FOUNDATION INVESTIGATION REPORT  
By: W.A. Trow & Associates, Ltd.

Re: W.P. 189-40,  
Sutherland Creek Crossing,  
Rwy. #2, near Quebec City,  
District #9.

RE: W.P. 189-60  
Hwy. 401 Service Rd. at  
Sutherland Ck., 2.3 Mi.  
W. of Quebec Boundary  
Dist. No. 9

FOUNDATION INVESTIGATION  
BRIDGE REPLACEMENT, HWY. NO. 2  
SUTHERLAND CREEK

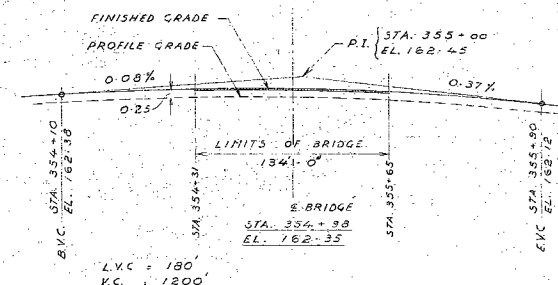
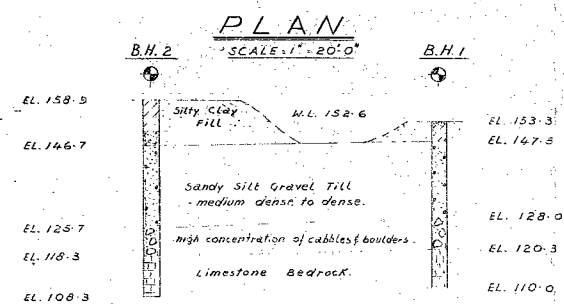
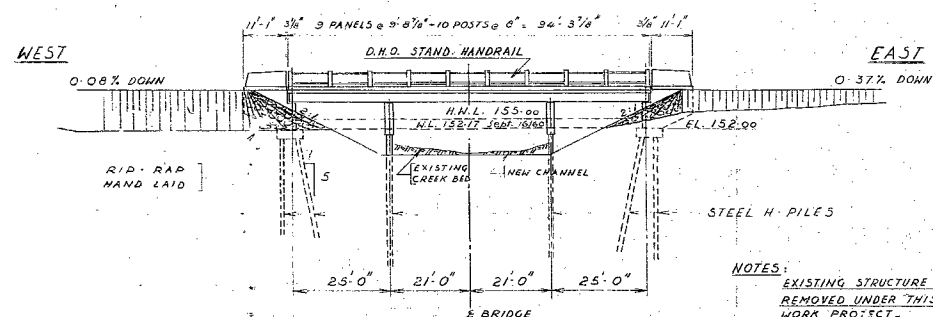
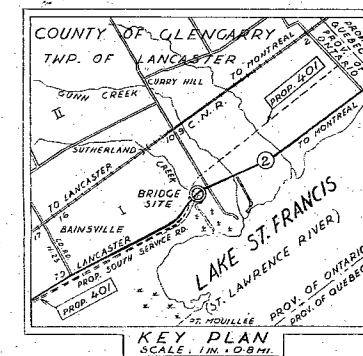
Enclosed find one print (D4962-P) of the preliminary plan for the subject structure.

The designer has used steel H-piles contrary to the recommendations of the foundation report. The reason we have chosen this type of pile was because of the strong possibility that this structure would be awarded to the same contractor to whom the upstream structures are awarded. In this case we are likely to get a very low unit price for piling.

Would you kindly let us have any comments you might like to make.

NO COMMENT
